| THIS PRINT IS THE<br>PROPERTY OF ITS CORP.<br>IT SHALL NOT BE COPIED<br>WITHOUT PERMISSION. |      |         |     | TITLE<br>SCH, 4 WAY<br>COMBINER BD<br>(1227-1311) |       |         |           |
| 1                                                                                           | 7559 | 7/25/94 | TRE | CHK                                               | DWB   | 2/17/94 | 1227-3311 |

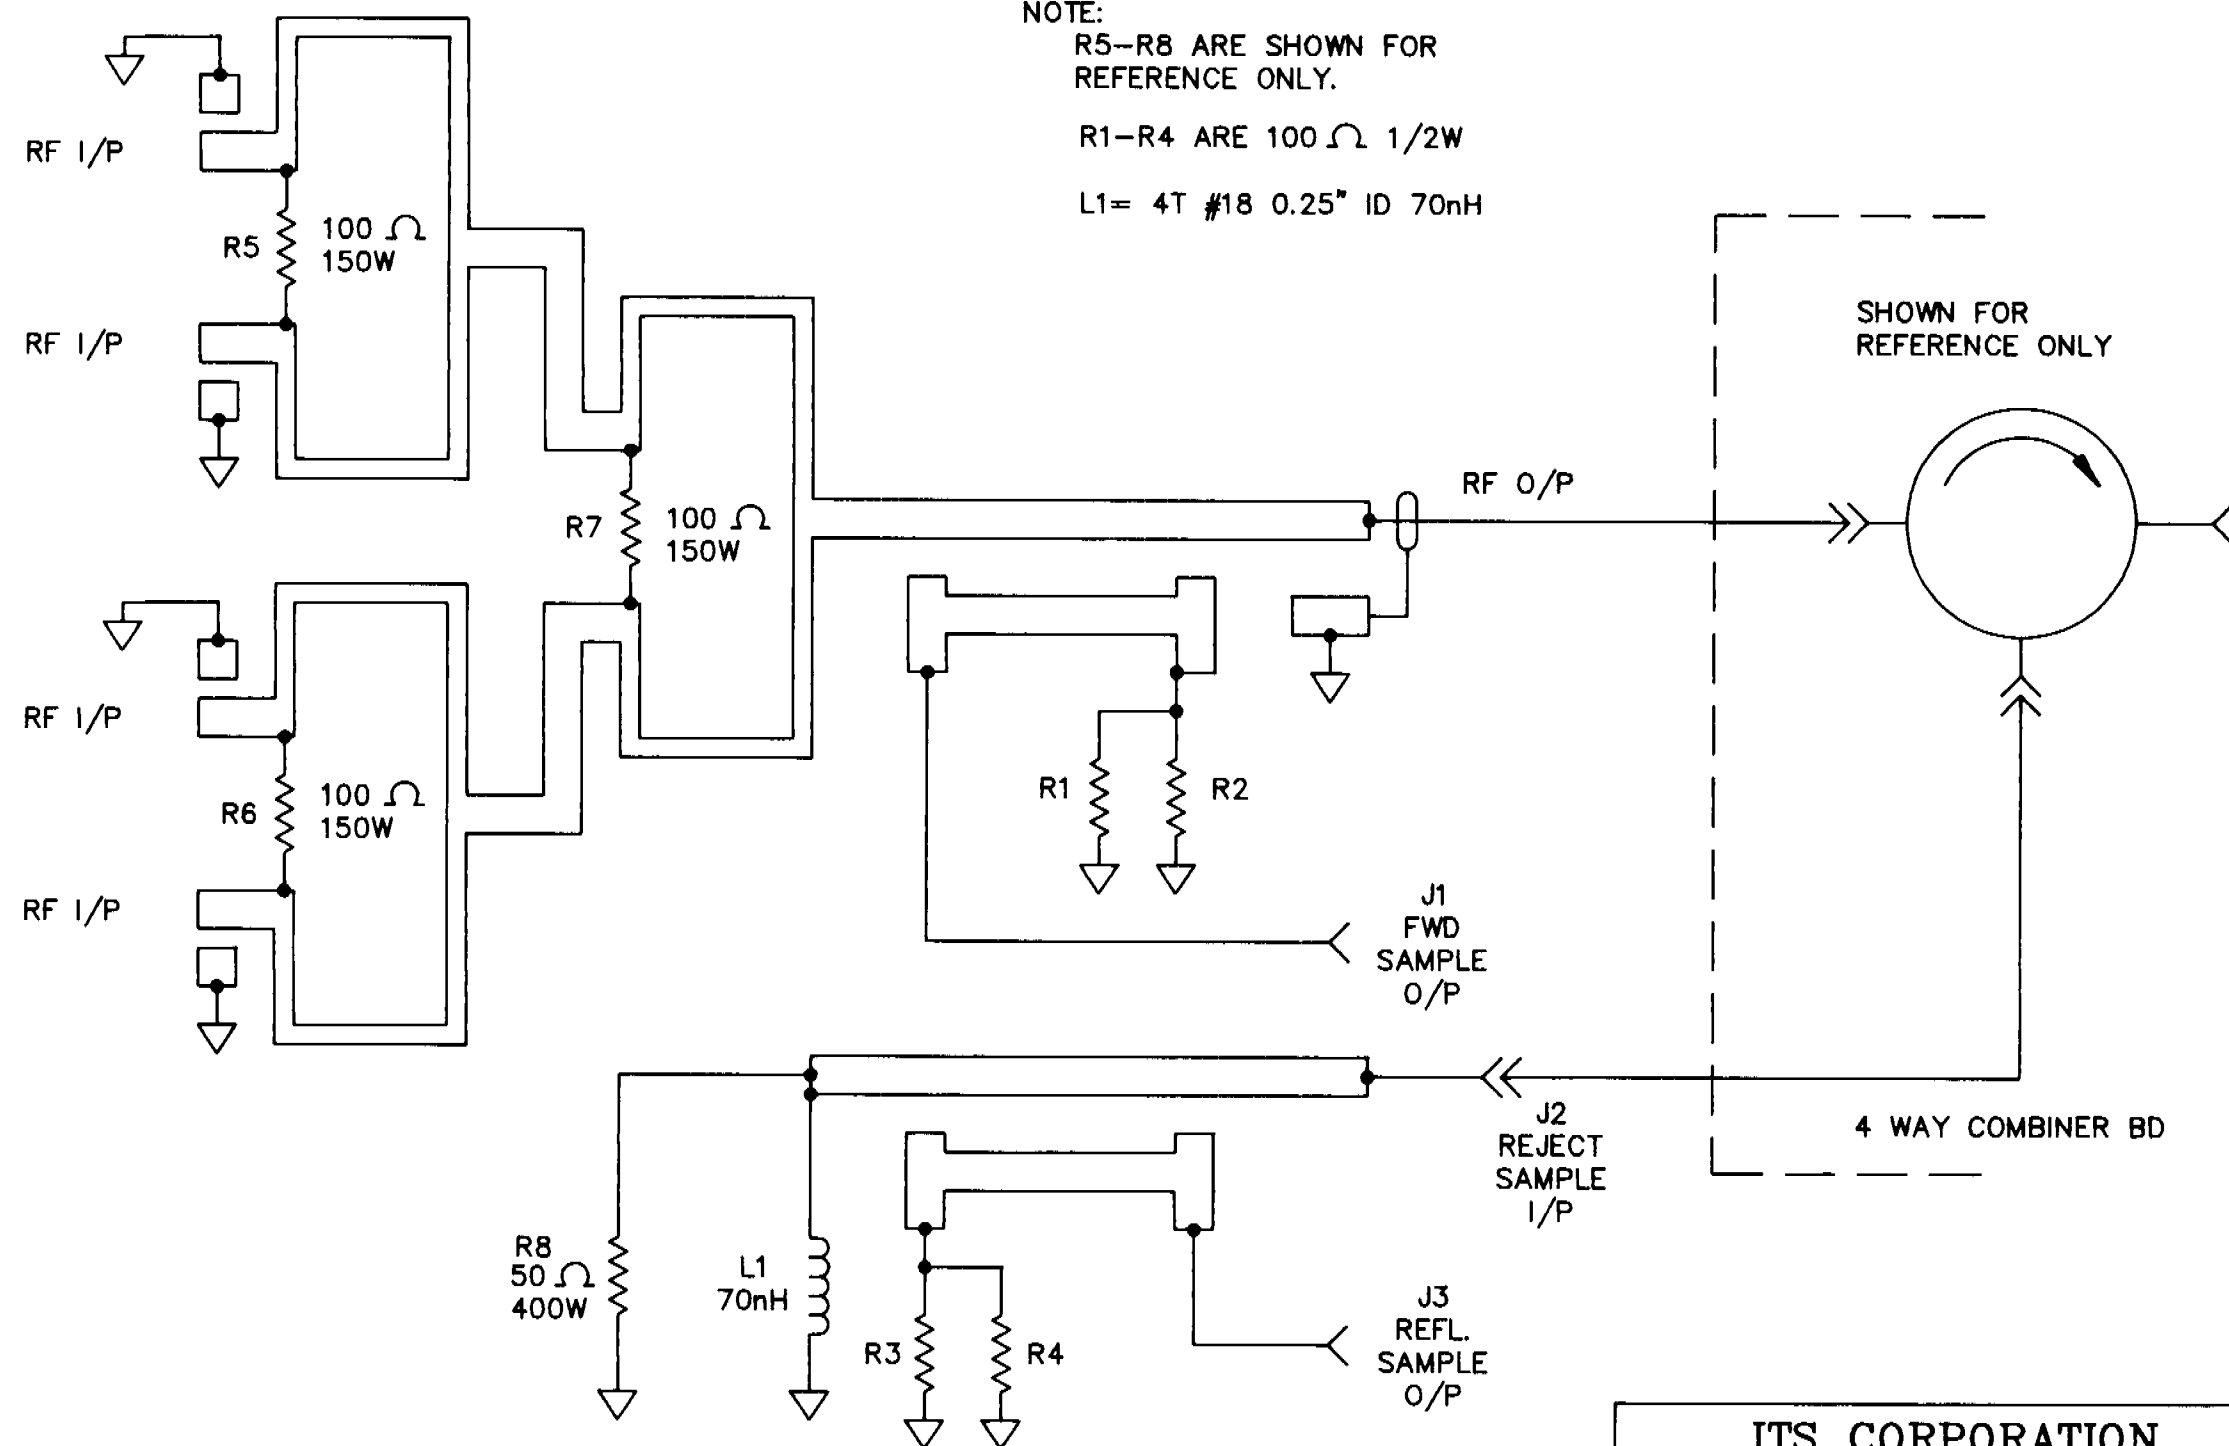
CHANGED R5, R6 AND R7  
 250W TO 150W. ADDED 70nH  
 TO L1, ALSO ADDED LABELING  
 TO J1, J2 AND J3. (RFB)
